### **3 Proposed changes**

Add N5:Login complete state to handle the successful completion of the login process and allows N0:Idle to be used for error cases.

### Link Negotiation

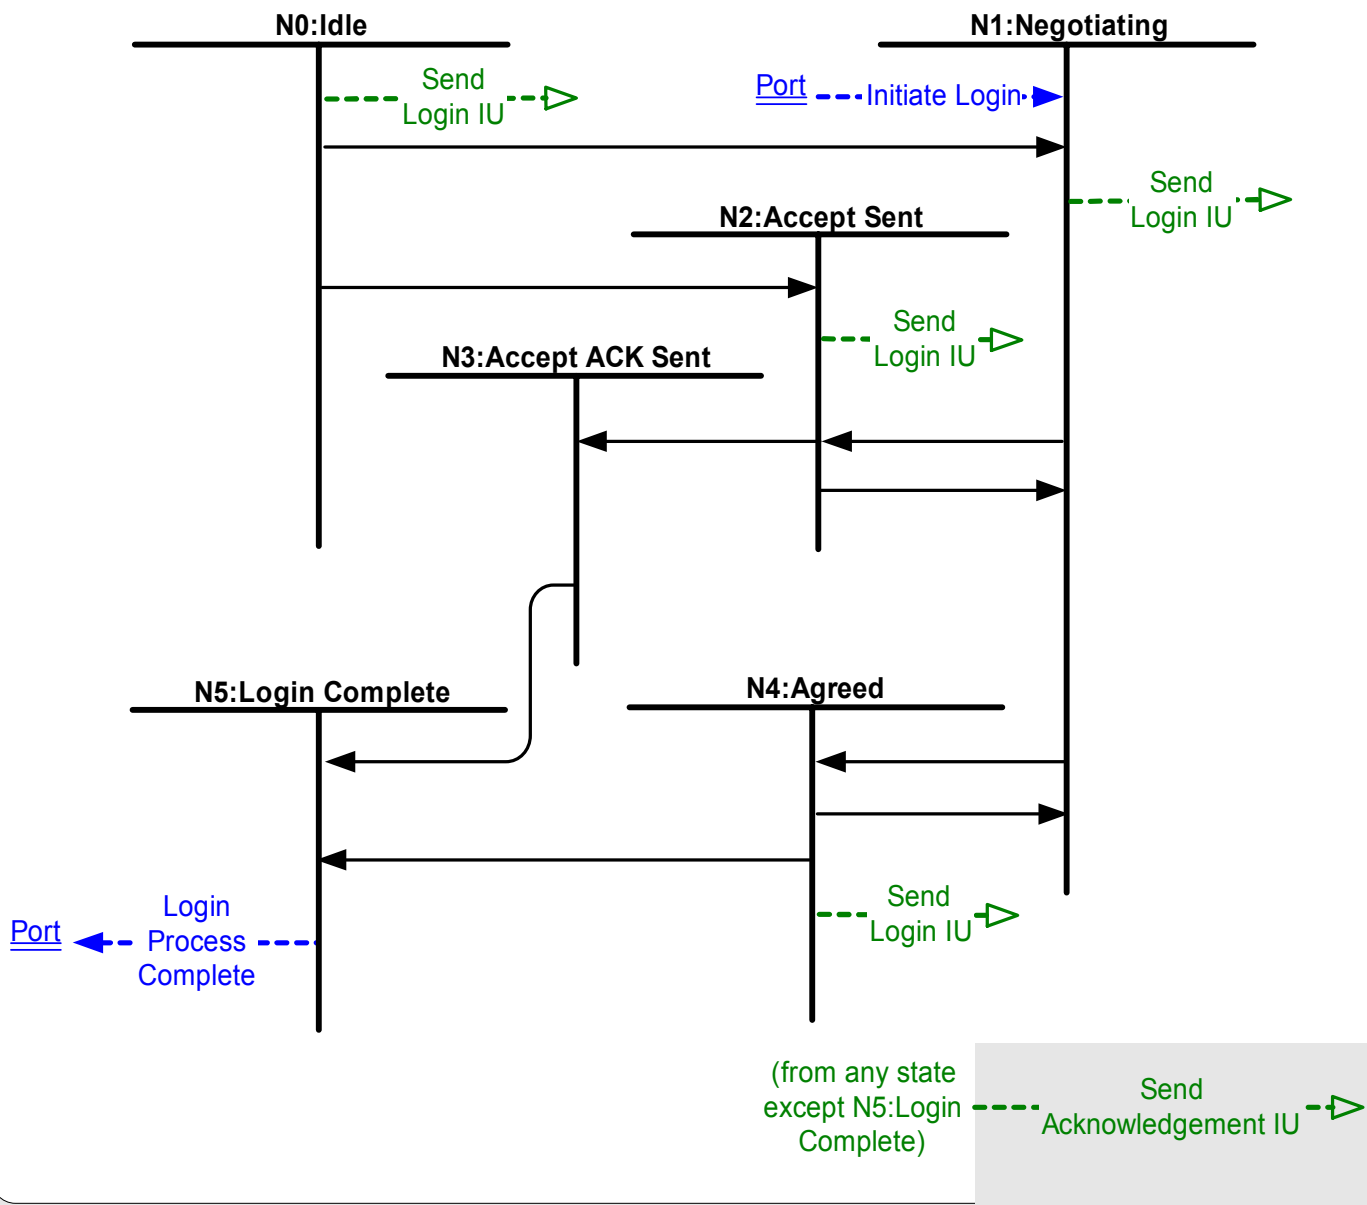
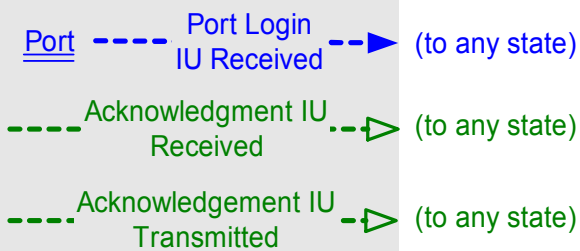
Globally change N4:Complete to N4:Agreed

replace existing Figure 5 Link Negotiation state diagram with the following diagram
